**Subject: Loveland Ready-Mix Concrete, Inc. (LRM)
Knox Pit Permit No. M-2017-036 - Sampling Reduction Request –
Response to Adequacy Review**

Loveland Ready-Mix Concrete, Inc. (LRM), represented by Telesto Solutions, Inc. (Telesto), is responding to your adequacy review for Technical Revision 2 (TR-2) regarding the proposed reduction in sampling frequency for Knox Pit, Permit No. M-2017-036. We appreciate your consideration of our responses to your review:

FIGURE 1
Proposed Point of Compliance Wells for Knox Pit – Permit No.: M2017-036

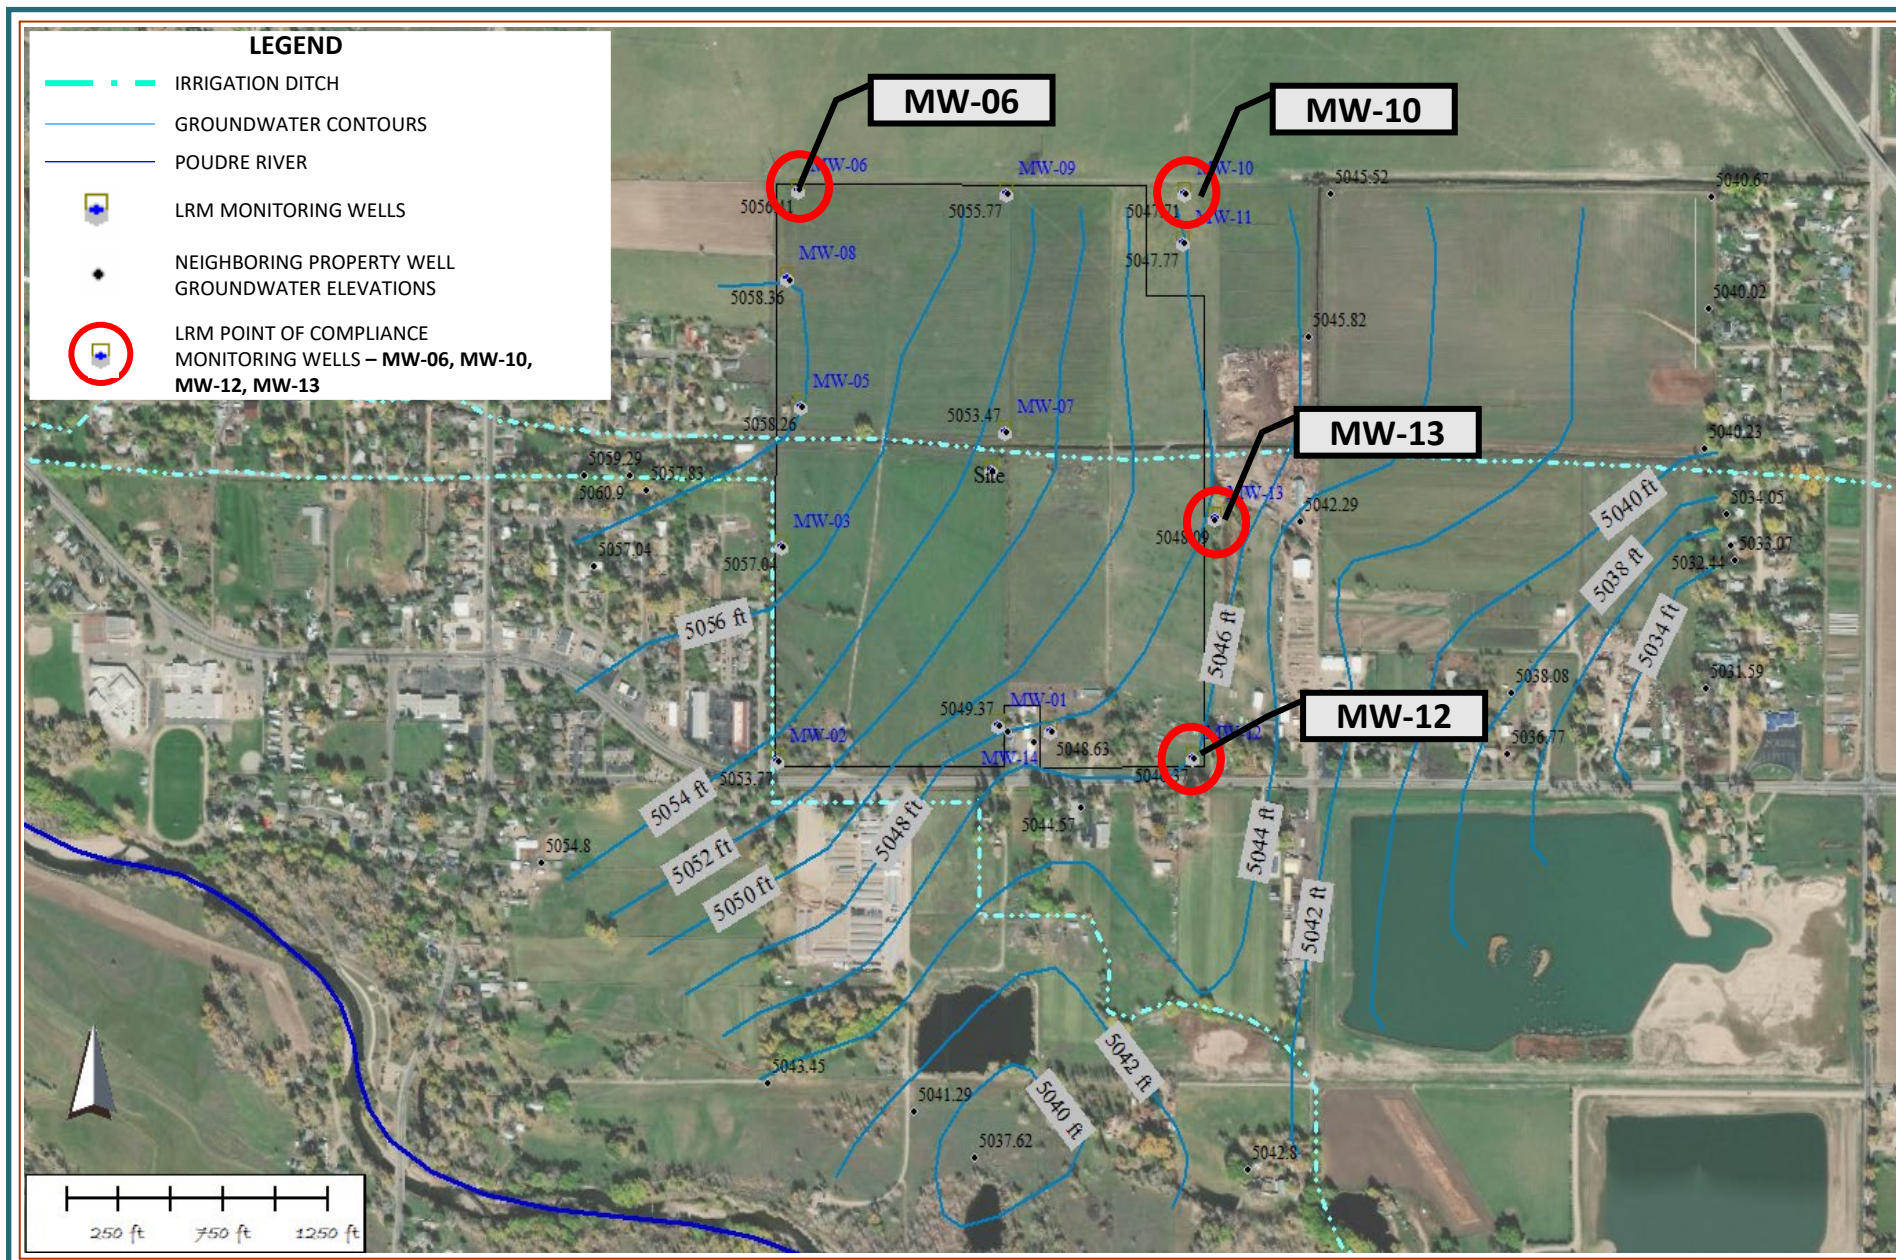
LRM commits to continue sampling monitoring wells MW-06, MW-10, MW-12, and MW-13 for points of compliance at Knox Pit (Figure 1). MW-06 provides groundwater quality data entering the site from the northwest corner, while MW-10 will monitor groundwater quality around the batch plant and any changes from on-site dewatering and/or recharge. MW-12 and MW-13 will monitor groundwater quality compliance as groundwater leaves the site towards the southeast (Figure 1). LRM believes identifying and sampling these four monitoring wells meets the criteria of Rule 3.1.7(6)(b).
